RS-20-038

Dresden Nuclear Power Station, Units 2 and 3
Renewed Facility Operating License Nos. DPR-19 and DPR-25
NRC Docket Nos. 50-237 and 50-249

Subject: Response to Request for Additional Information for the License Amendment
Request to Change Technical Specifications to Increase Allowable MSIV Leakage
Rates and Revise Secondary Containment Surveillance

Figure RAI-2a: Time-Dependent Aerosol Particle Size Distribution

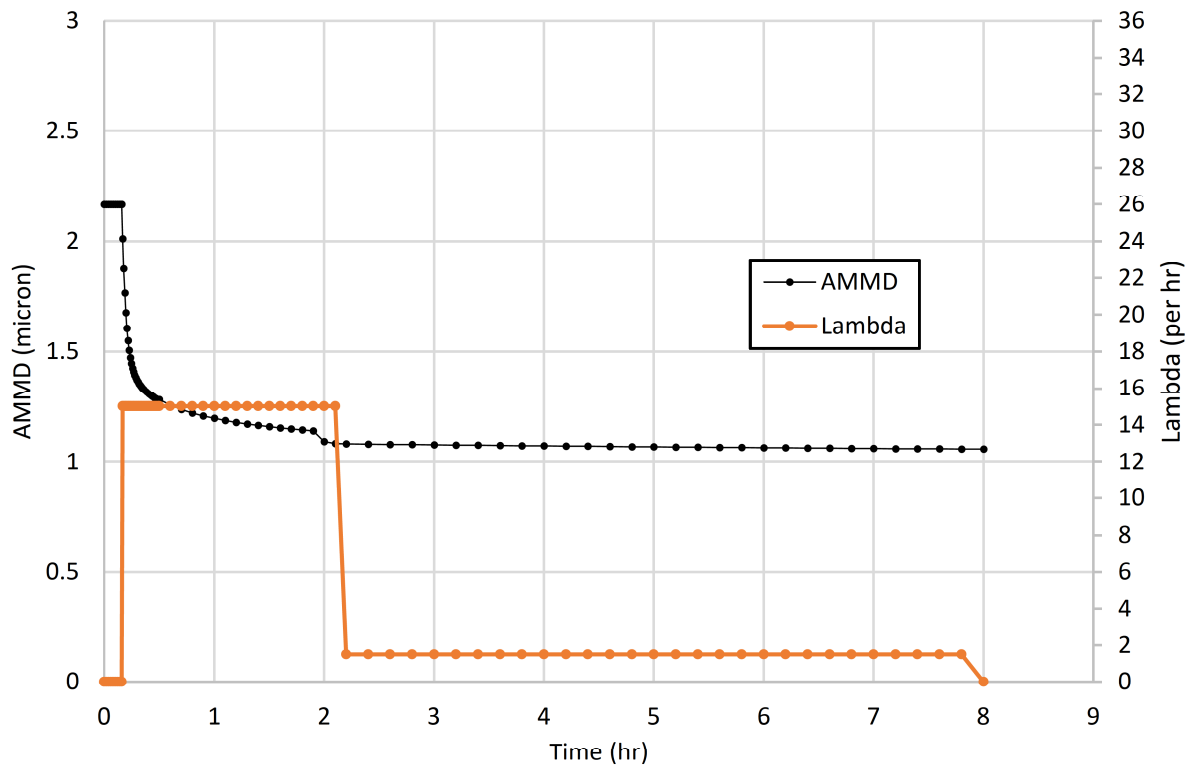
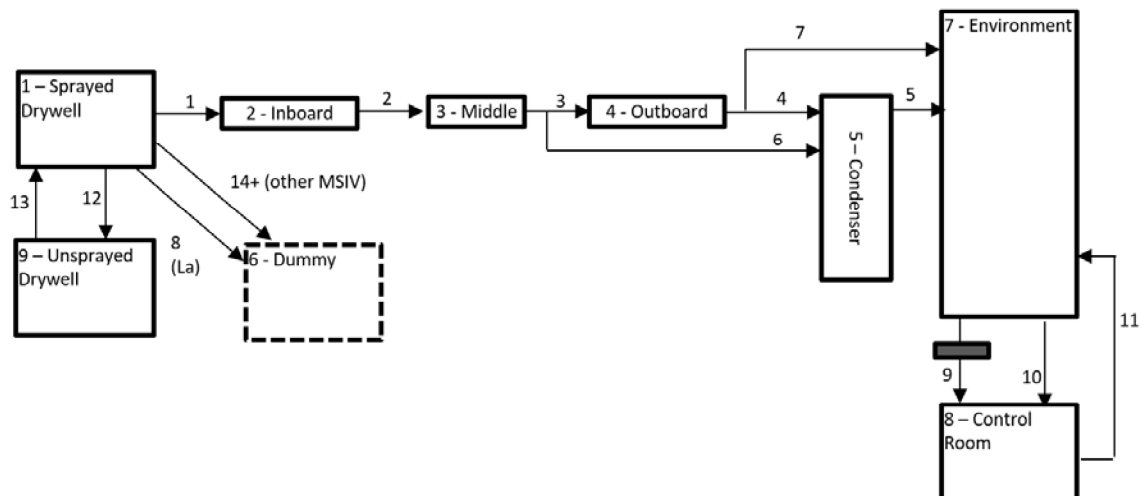
Please provide justification as to why the proposed aerosol settling velocity and model to credit sprays in the DNPS design is consistent with Reg 1.183, Revision 0. Please include sufficient technical detail to enable the NRC staff to perform an independent assessment on this aerosol settling velocity and model, and the subsequent calculated control room and offsite doses.

The sensitivity analysis modified the nodalization of the main steam line to overcome limitations of the RADTRAD code. The Unit 2 DRE05-0048 nodalization was modified to separately model each of the four main steam lines as shown in Figure RAI-2b. As a result, each sensitivity case includes four RADTRAD models, one for each line with three well-mixed nodes per line.

A simplified model was developed using first principles as identified in NUREG/CR-5966, "A Simplified Model of Aerosol Removal by Containment Sprays." Specifically, the ordinary differential equation shown on page 1 of NUREG/CR-5966 was solved to provide an analytical solution of the suspended aerosol mass in the drywell. The spray removal rate in this simplified model is the same as that identified in DRE05-0048 Section 2.1.3 and RG 1.183, Appendix A, Section 3.3. Since sprays will remove aerosols at different rates depending on their particle size, the spray removal rate is adjusted by collection efficiency variation as provided in Figure 19 of NUREG/CR-5966. The suspended aerosol mass was solved from the beginning of the accident through the termination of the sprays for 20 distinct particle size groups. The mass of particles in each group is defined by the probability distribution associated with the source distribution.

The size distribution of the particles released from the fuel was assumed to be a log-normal with 2 micron Aerodynamic Mass Median Diameter (AMMD) (0.473 micron geometric mean diameter) with a Geometric Standard Deviation (GSD) of 2. The aerosol mass was calculated for each group independently with no consideration of particles interacting with one another. Therefore, agglomeration is not accounted for, and this conservatism will artificially and permanently lower the average particle size as large particles are removed and not replaced. The result is a much smaller gravitational settling and spray removal rate. Table RAI-2a summarizes the results of the 20-group particle size distribution in the drywell. Figure RAI-2a visually illustrates the time-dependent nature of the aerosol particle size distribution. As shown in Figure RAI-2a, the effect of the drywell spray in reducing the size of the particles is accounted for in the model.

- Inclusion of all four main steam lines for holdup and deposition and associated nodalization changes shown in Figure RAI-2a
- Inclusion of outboard main steam line piping holdup and deposition
- Revised aerosol removal factors that consider the impact of sprays
- Removal of deposition upstream of an inboard MSIV (see ARCB-RAI-4 response)
- Increased spray duration from 4 hours to 8 hours (see ARCB-RAI-4 response)
